# PLANNING COMMISISON SITE PLAN WAIVER REQUEST REVIEW SHEET

SP-2012-0440C

Austin Chinese Church New Sanctuary Building

OVERALL SITE PLAN

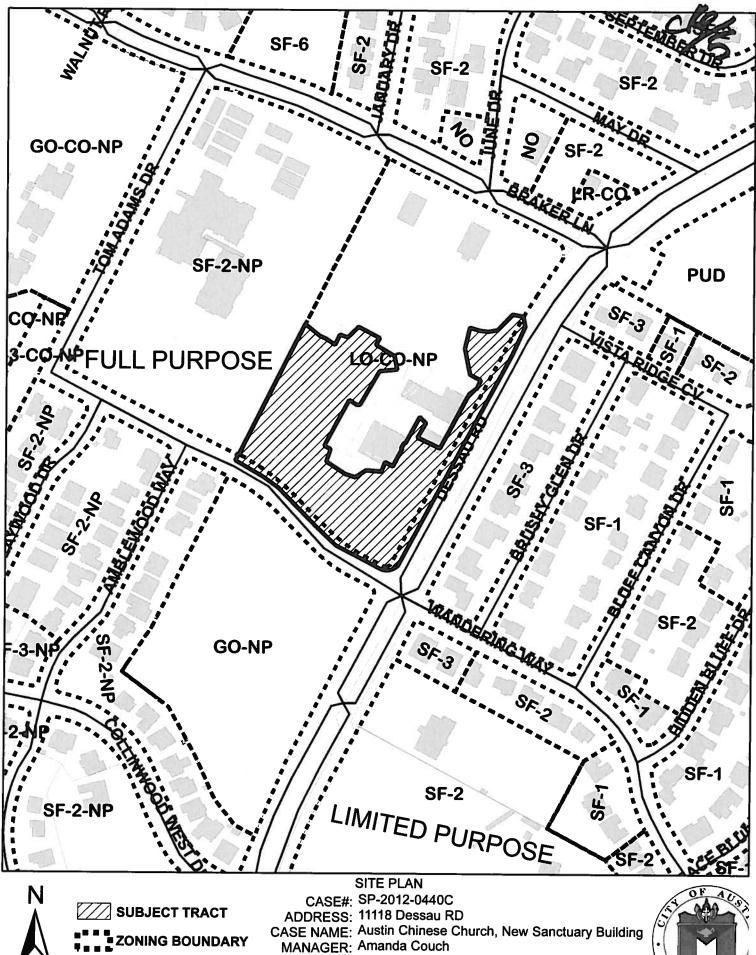
The applicant is requesting a waiver from § 25-2-1067(G)(2), which requires a parking area setback of 25 ft. from property zoned as SF-5 or more restrictive. The project is proposing a parking lot 13ft. from the west property line, therefore encroaching on the set back by 12ft. Adjacent to the West of the property is a lot zoned SF-2- NP occupied by an elementary school.

The site is subject to Compatibility Standards due to the adjacent lot zoned SF-2-NP to the west. Per Section 25-2-1067(G)(2) of the Land Development Code — a parking area or driveway may not be constructed 25 feet or less from a lot that is in a SF-5 or more restrictive zoning district. The applicant is proposing to encroach in the 25 ft. compatibility set back by 12 ft.

All other compatibility setbacks and standards are met. There is adequate vegetative screening to the adjacent SF-2 lot to the west. The applicant has added notes to their site plan related to exterior lighting, noise levels, trash location, and highly reflective surfaces, as required per the Land Development Code.

Staff recommends approval of the waiver requests. The applicant has the support of the public school which occupies the adjacent lot and has provided vegetative screening. The site plan complies with all other requirements of the Land Development Code. The proposed parking lot will not encroach into the set back any more than the existing, permitted parking lot.
